Hoffmann Drilling Pty Ltd Superannuation Fund v Gold Coast City Council & Ors

Planning and Environment Court Appeal No 137 of 2020

Third Joint Expert Report on groundwater issues between the following:

Figure 1 Site Bore Locations

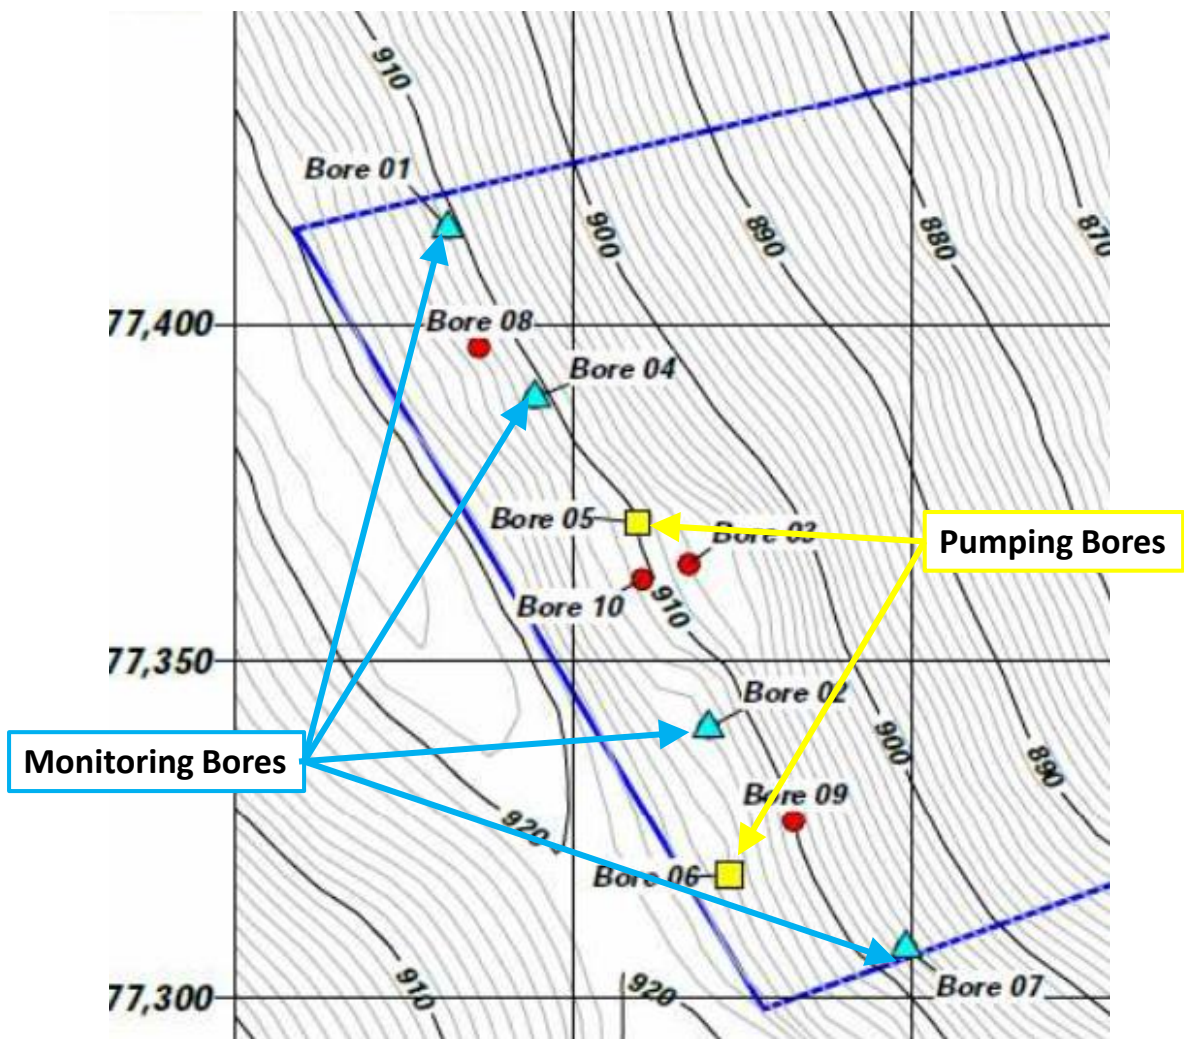
- Figure 1 shows the two bores from which water was extracted in the July test (Bores 5 and 6 - see also Bullet Point 4 below) and the four key monitoring bores (Bores 1, 2, 4 and 7);

Figure 2 Absolute Bore Water Level Data for July

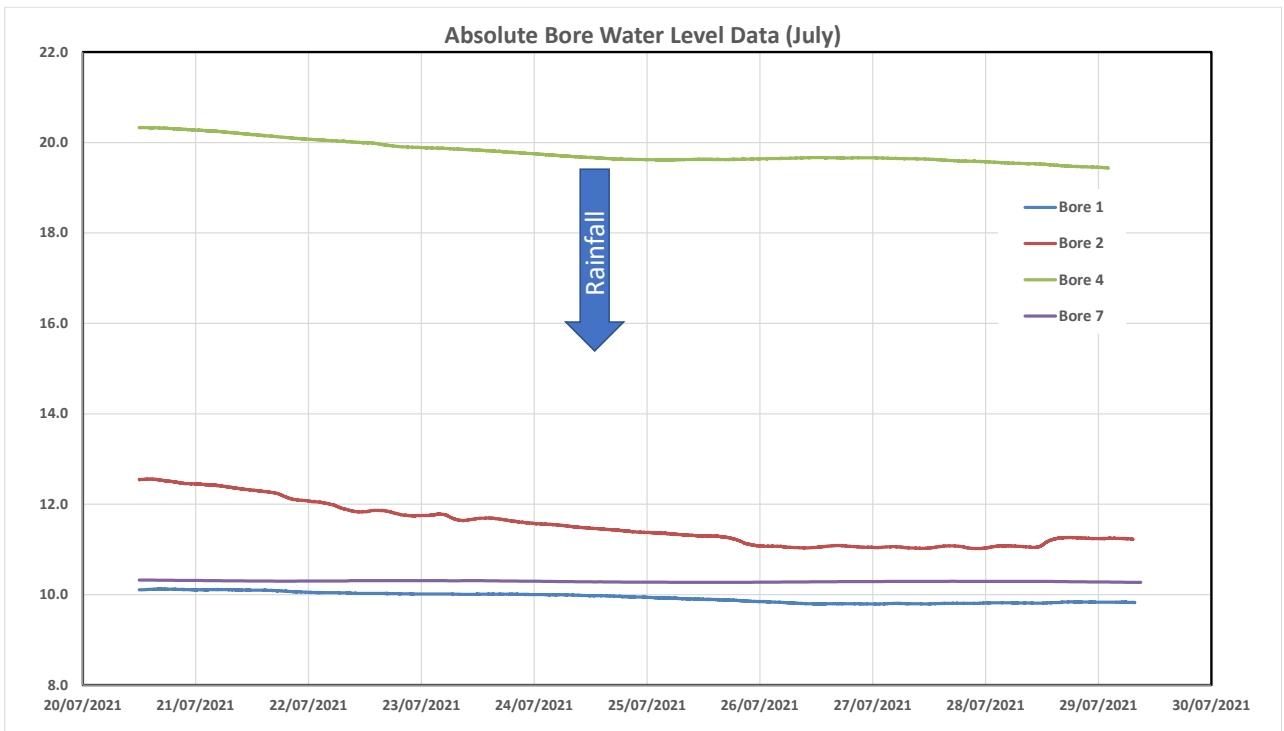
- Figure 2 shows the **actual** water level data recorded in each bore, which are different in vertical scale due to the specific details of the bores, where loggers are located, and what layers of the site aquifer(s) are intersected;

- This is evident from Figure 2, Figure 3, Figure 8 and Figure 9 with the data from Bore 7 showing little, if any, water level variation, either due to pumping or from rainfall recharge.

Figure 3 Relative Bore Water Level Data for July

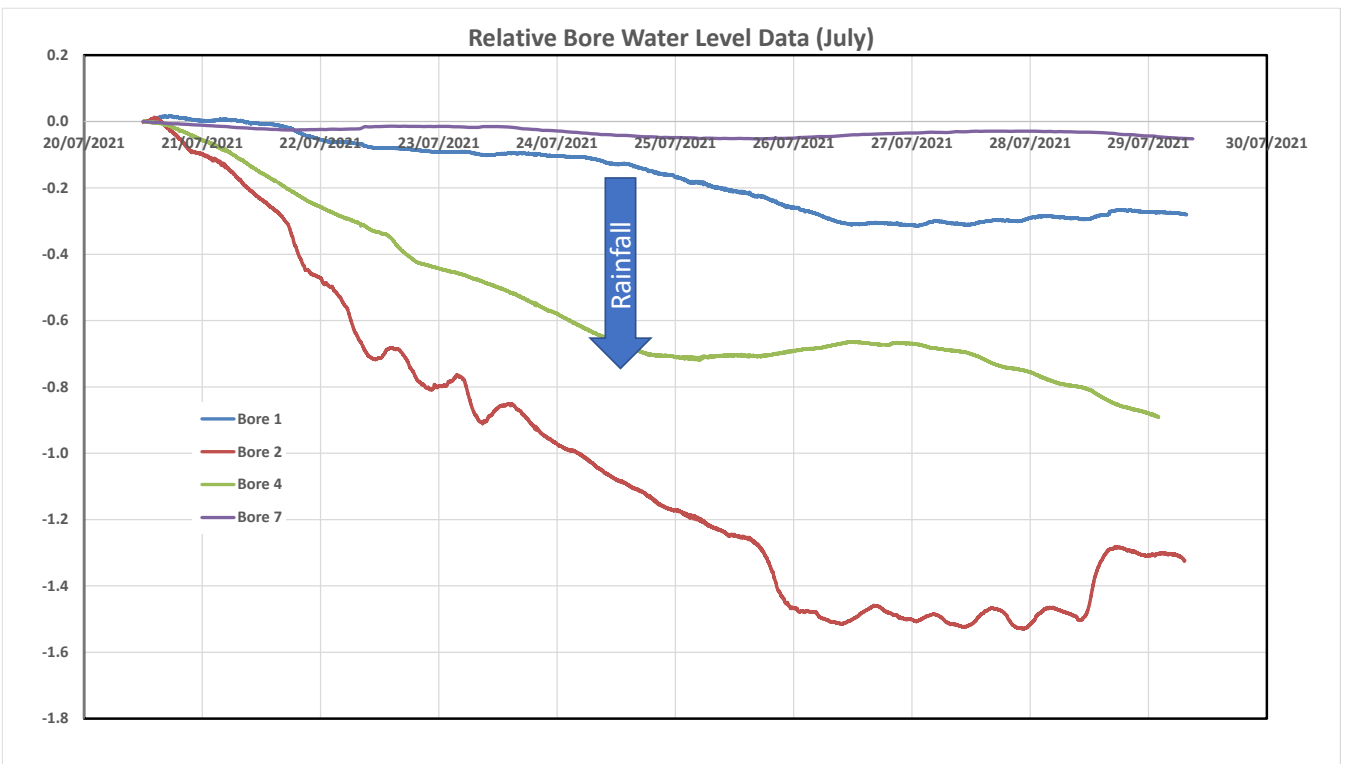
- Figure 3 shows the **change** in water level which occurs in each bore. This figure conclusively shows that after 7 days of pumping, water levels in Bore 2 (located midway between the extraction bores) reduced by 1.4m, water levels in Bore 4 (located midway between the extraction bores and the northern site boundary) reduced by 0.9m, and water levels in Bore 1 (located near the northern site boundary) reduced by 0.3m. Importantly, all three records were trending downwards, meaning that if the pumping had continued (as would be expected if year-round pumping at the proposed rate of 16 ML/year is permitted), greater reductions in water level would have occurred; and

23. TJ says that the use of a single thick blue line to represent rainfall in Figures 3 and 4 is significantly misleading and inaccurate. Rainfall should be shown as an hyetograph with each bar representing the rainfall which actually occurred on each day, as per the charts produced by Ian Hair. The actual rainfall which fell during the monitoring period at the Wunburra Gauge was 19.2 mm on 24 July, and zero on the other days. It is noted that low rainfall totals generally do not reflect in any measurable change in groundwater level. For Tamborine Mountain, the QUT researchers found that rainfall events up to 30 – 40 mm or less did not translate into any recharge to groundwater. A similar type of behaviour is likely to occur in the Springbrook area. If this is the case, then the rain falling during the monitoring period is unlikely to have had any measurable effect on groundwater levels.

24. MC and TM believe that the use of the arrow is appropriate to indicate when the rainfall event in question occurred.
25. TM and MC agree that rain events below 30 mm are unlikely to result in any significant recharge to groundwater (as discussed under 90), and believe that the downward dry season pumping test water level trend (accounting for periods of reduced extraction when one of the bores was pumped dry) in itself supports the view that pumping at the proposed rate in the dry season is unlikely to be sustainable, regardless of the whether the rain event in question influenced groundwater levels during the test.

Figure 4 Rainfall data for 2021, indicating timing of pump test

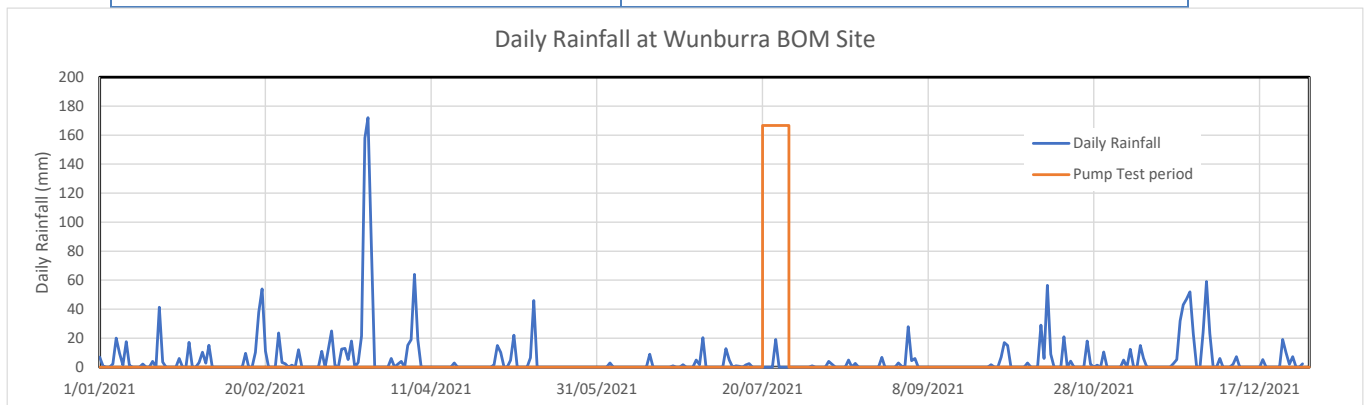
- Figure 4 shows daily rainfall data for 2021 for the BOM Wunburra gauge on the Springbrook Plateau while Figure 5 shows similar daily rainfall for June and July 2021. It is apparent from these figures that there was considerable rainfall in the weeks leading up to the pump test, and as stated earlier, during the period when the test occurred, which will mean that impacts of groundwater extraction during extended dry periods (which are not uncommon) are likely to be underestimated by the testing;

27. TJ says that the Wunburra gauge significantly underestimates the depth of rainfall which falls on the catchment above 830 m AHD. The Wunburra station has an elevation of only 566 m, and reliance on the statistics for that gauge may lead to erroneous and misleading findings. TJ accepts that 2020 and 2021 were wetter years than average, and that drawdown might be greater in a drier year. However, we can only deal with the information that we have in my opinion. In that respect, the data collected by Hair has been used to calibrate the analytical groundwater model, and it is the results of that modelling which are considered pertinent here.

Figure 6 Rainfall data for 2021 at Springbrook Road gauge, indicating timing of pump test

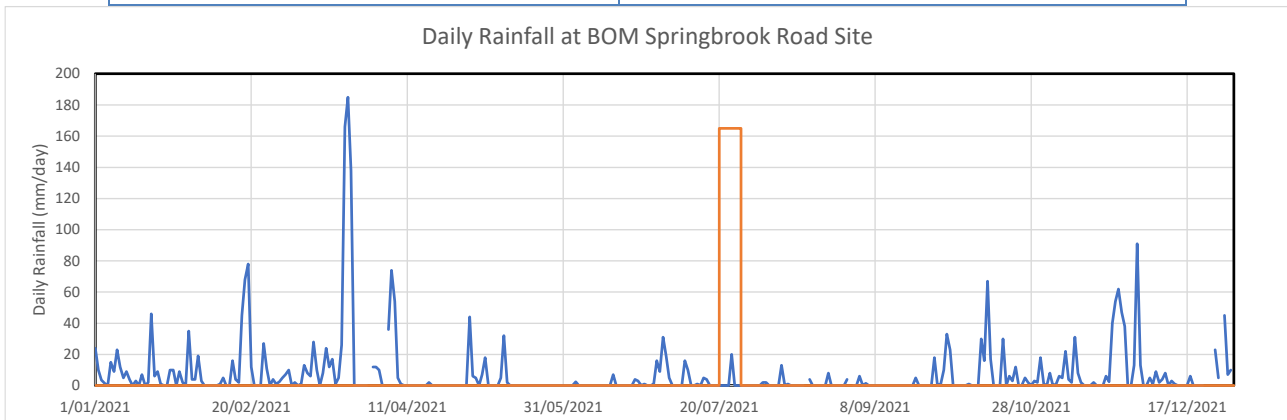
28. TM and MC note that the Wunburra data was presented because this site has the longest data record (some 60 years). They also present Table 3 which is the analysis of some 37 years of rainfall data for the nearby Springbrook Road gauge (elevation 697m) and Figure 6 and Figure 7 which show daily rainfall data for 2021 for the BOM Springbrook Road gauge on the Springbrook Plateau and similar daily rainfall for June and July 2021. These data confirm their comments regarding 2020 and 2021 being wetter years than average based on the Wunburra data. Figure 7 actually shows that there was **even more rainfall** in the weeks leading up to the 'dry' season pump test at these sites than was the case using the Wunburra data - making it even less representative of dry season conditions.

Figure 8 Daily Rainfall and Recorded Groundwater Levels – 2021

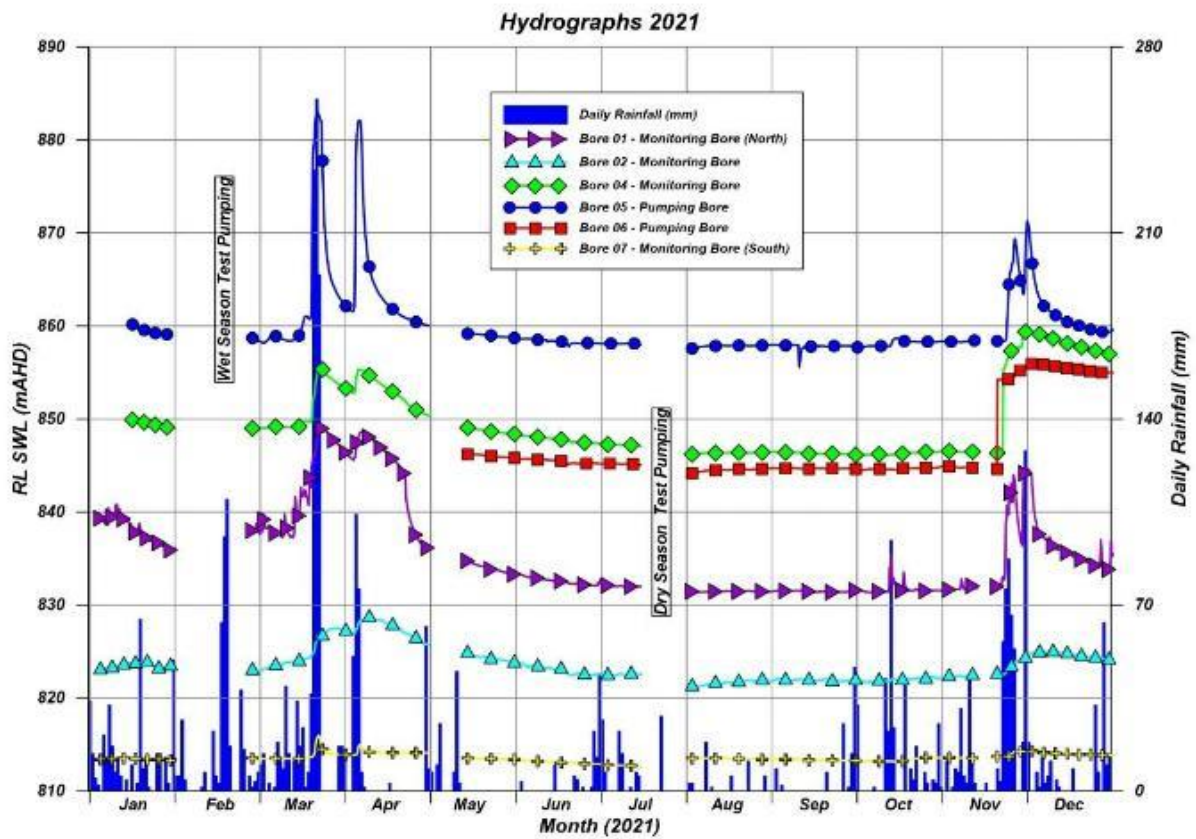
34. TJ says that the reliance on observations made by a third party who is neither a hydraulic engineer nor a hydrogeologist is questionable. TJ says that, in his opinion, there is every reason to believe that seepage occurs generally above the rhyolite layer from 820 m AHD up to the recorded water table level in the extraction bore of about 830 m AHD (which also corresponds to the upper level of spring activity on the site). There is nothing in the geology of the site which would affect such a conclusion. This is clearly illustrated on the following Figure 8 in respect of bores 2 and 7.

Figure 11 – Modelled drawdown under no-rainfall scenario (reproduced from SLR, 2022).

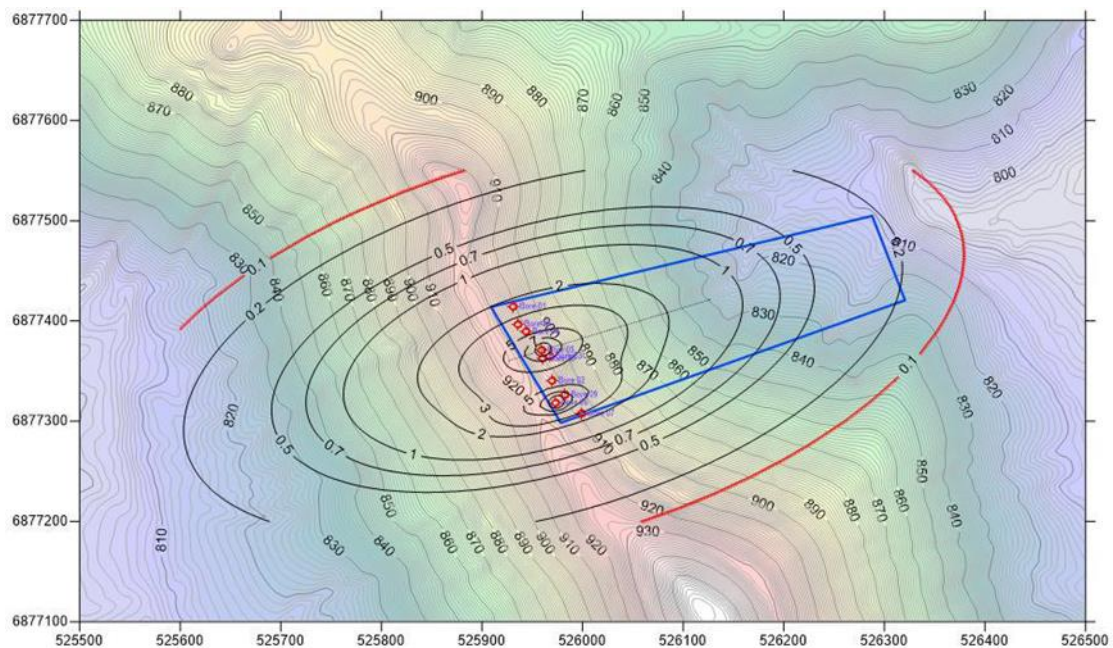
87. TM and MC note that the modelled drawdown shown in Figure 6 of SLR, (2022) (reproduced below) clearly extends well beyond the western boundary of the property, in direct contradiction of TJ's opinion:

88. TJ accepts that there are water table level impacts on the western side of the ridgeline, but that these impacts are unlikely to be unacceptable for the same reasons that the eastern impacts are not unacceptable.

Plate 2: Small groundwater spring to the west of the extraction bores (outside the property boundary) which occurs at elevation of approximately 831 m AHD, which provides habitat for crayfish.

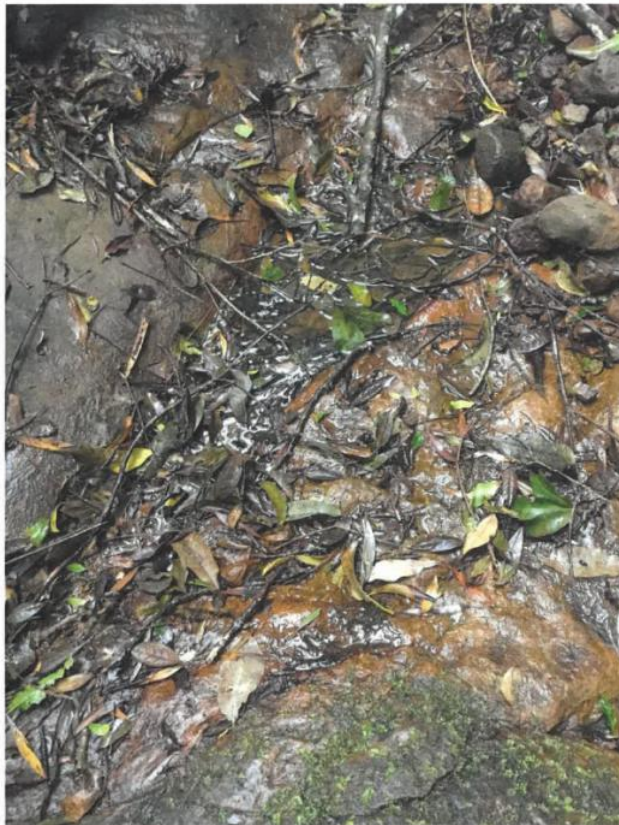
103. MC believes that in addition to the likely impacts on surface water flows to the east of the bores noted above, flow of groundwater to Cave Creek (to the west of the site) may also be impacted, as it crosses the 830 m contour to the southwest of the bores (albeit at a greater distance than the spring which ultimately feeds Twin Falls to the east). This creek sustains flows to Natural Arch, another site of high cultural significance. The springs and seeps to the west of Repeater Station Rd that were documented in the affidavit of Elanor Fenge also likely provide important environmental water; for example, a crayfish was identified in the small spring mapped to the west of the bores (site W2 in the affidavit) at elevation of approximately 831 m AHD (Plate 2 below).

105. TJ does not understand how a photo of a crayfish at a site somewhere on the Mountain is in any way relevant to the matter being considered by the groundwater experts. TJ is not an expert in astacology (the study of crayfish), and can make no meaningful response to these photographs.
